TRANS/WP.29/749 8 December 2000

World Forum for Harmonization of Vehicle Regulations (WP.29)

DRAFT SUPPLEMENT 6 TO REGULATION No. 43

(Safety-glazing)

Figure 1: Test area "A" (example of a left-hand steering control vehicle)

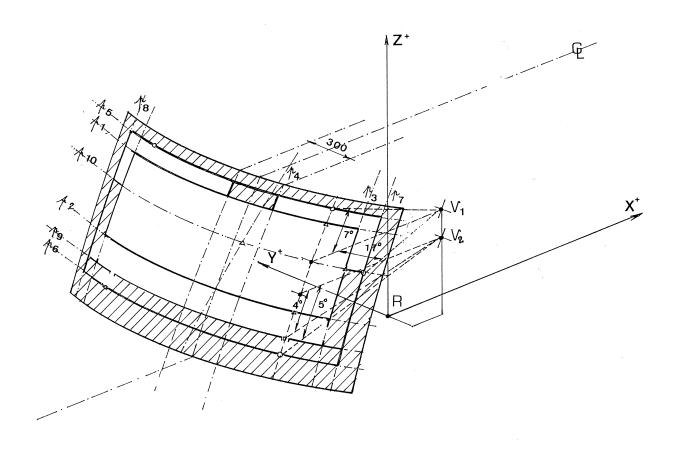
- "2.2. "Test area A" is the area of the outer surface of the windscreen bounded by the intersection of the following four planes (see figure 1):
  - (a) a plane inclined upwards from the X axis at 3E, passing through  $V_1$  and parallel to the Y axis (plane 1);
  - (b) a plane inclined downwards from the X axis at 1E, passing through  $V_{2}$ , and parallel to the Y axis (plane 2);
  - (c) a vertical plane passing through  $V_1$  and  $V_2$  and inclined at 13E to the left of the X axis in the case of left-hand drive vehicles and to the right of the X axis in the case of right-hand drive vehicles (plane 3);
  - (d) a vertical plane passing through  $V_1$  and  $V_2$  and inclined at 20E to the right of the X axis in the case of left-hand drive vehicles and to the left of the X axis in the case of right-hand drive vehicles (plane 4)."

## Figures 1 to 3, amend to read:

Figure 2a: Reduced test area "B" (example of a left-hand steering control vehicle) - upper obscuration area as defined in paragraph 2.4.2.2.

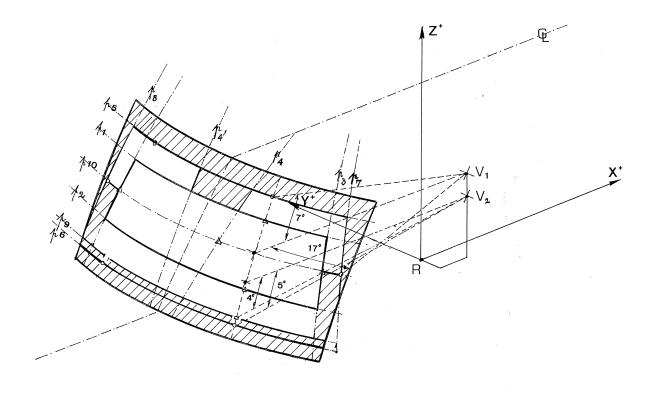
"2.4. The "reduced test area B" is test area B with the exclusion of the

- following areas 1/ (see figures 2 and 3).
- 2.4.1. the test area A defined under paragraph 2.2., extended according to paragraph 9.2.2.1. of annex 3;
- 2.4.2. at the discretion of the vehicle manufacturer, one of the two following paragraphs may apply:

- 2.4.2.2. any opaque obscuration bounded downwards by plane 1, of maximum width 150 mm  $\underline{2}$ /, provided it is inscribed in an area of width 300 mm centred on the longitudinal median plane of the vehicle;

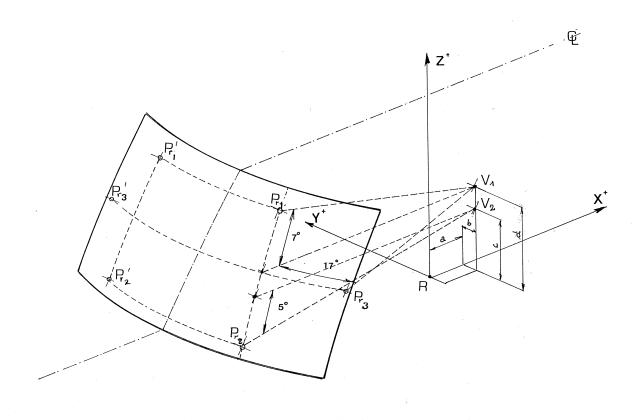
- (d) with plane 9;
- 2.4.5. an area within 25 mm from the edge of the outer surface of the windscreen or from any opaque obscuration. This area shall not impinge on the extended test area A.
- 2.5. Definition of the datum points (see figure 3)

The datum points are points situated at the intersection with the outer surface of the windscreen of lines radiating forward from the V points:

- 2.5.1. upper vertical datum point forward of V1 and 7E above the horizontal (Pr1);
- 2.5.2. lower vertical datum point forward of V2 and 5E below the horizontal (Pr2);
- 2.5.3. horizontal datum point forward of V1 and 17E to the left (Pr3);
- 2.5.4. three additional datum points symmetrical to the points defined under paragraphs 2.5.1. to 2.5.3. in relation to the longitudinal median plane of the vehicle (respectively Pr'1, Pr'2, Pr'3)."
